Service Notice Number: 20200910-2

Increased Risk of Error 82 on LN-25X and ACTIV8X

Product(s) Covered:

LN-25X: Lead 707 being rerouted thru toroid. Direction arrows show routing from flexible power pc board to user interface pc board.

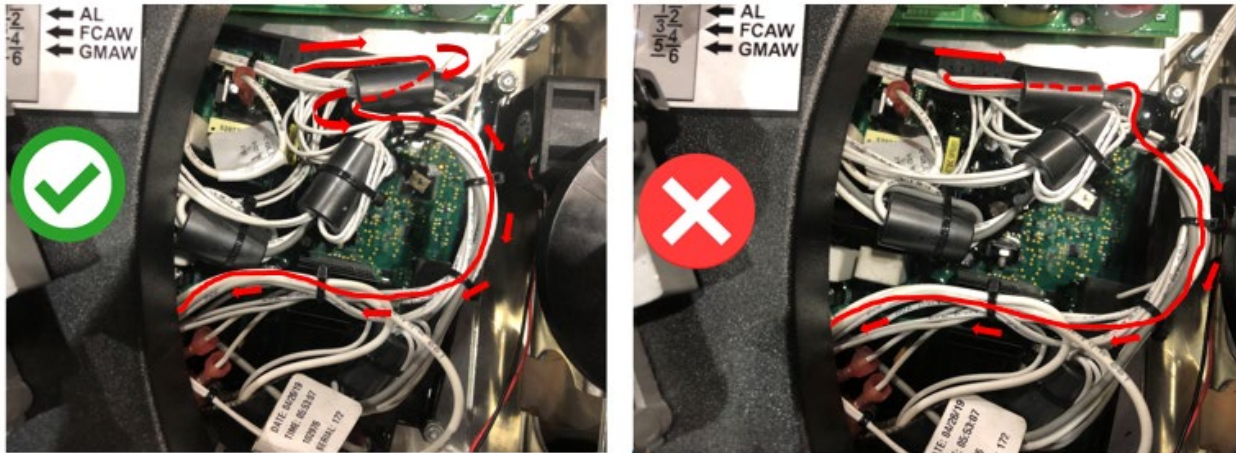
LN-25X and ACTIVE8X feeders may experience a higher risk of Error 82 due to electrical noise.

- A Molex removal tool is required for this repair (Molex Mini Fit 11-03-0044).
- Remove the wire drive assembly and control box cover to access the flexible power pc board.
- Locate wire lead 707 and disconnect it from the P6 Molex pin 8 using the Molex removal tool (note, the locking post needs to be removed first).
- Reroute wire lead 707 through the toroid containing the P1 leads 510, 511, 512, 513, 517, 518, 519. The direction does matter. See illustration of the correct routing below.

- Reconnect the wire lead 707 to the P6 Molex pin 8 and reinsert locking post.
